**SHOP DRAWING / SUBMITTAL REVIEW**

202403-55338  
 Case Residence  
 34159 Lowry Lane  
 Slidell, Louisiana 70460  
 2nd Flr

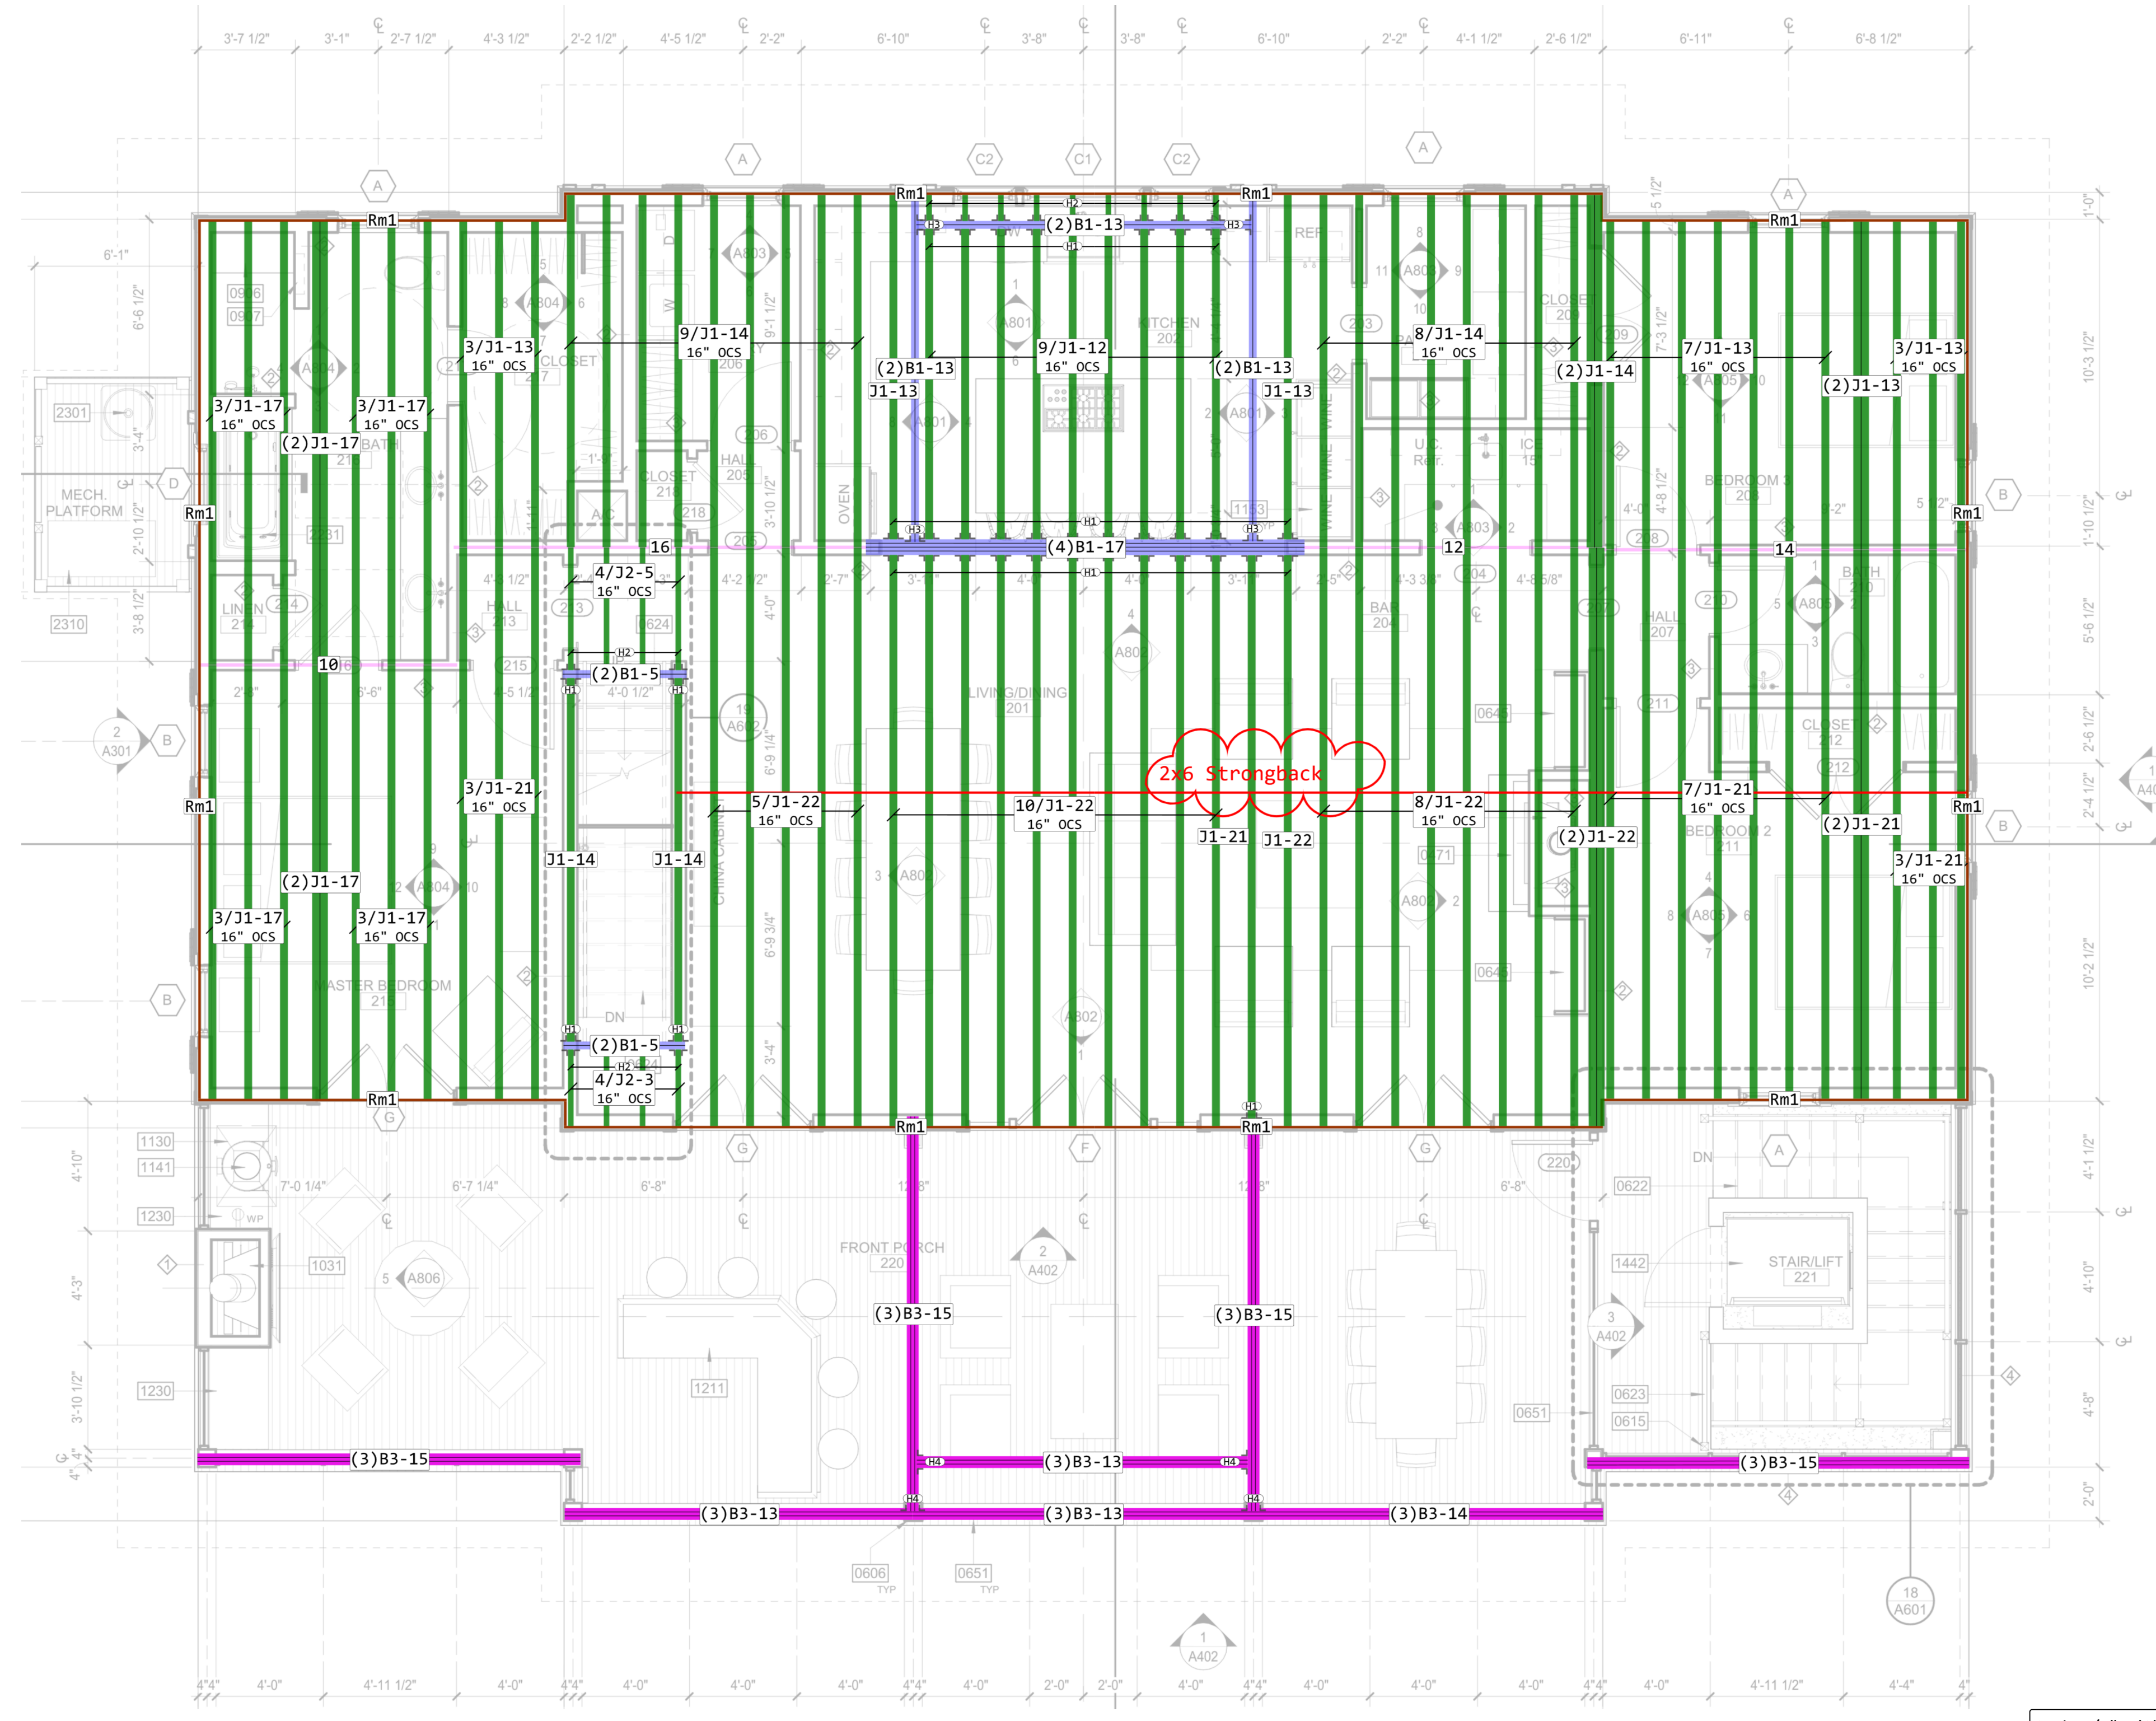
All of these beams need to be at the same level as the OJ2000 to support wall(s) above.

(2) B1 to support the exterior wall

This area past the wall is porch area. The porch area will use 2x12 @ 16" o.c.
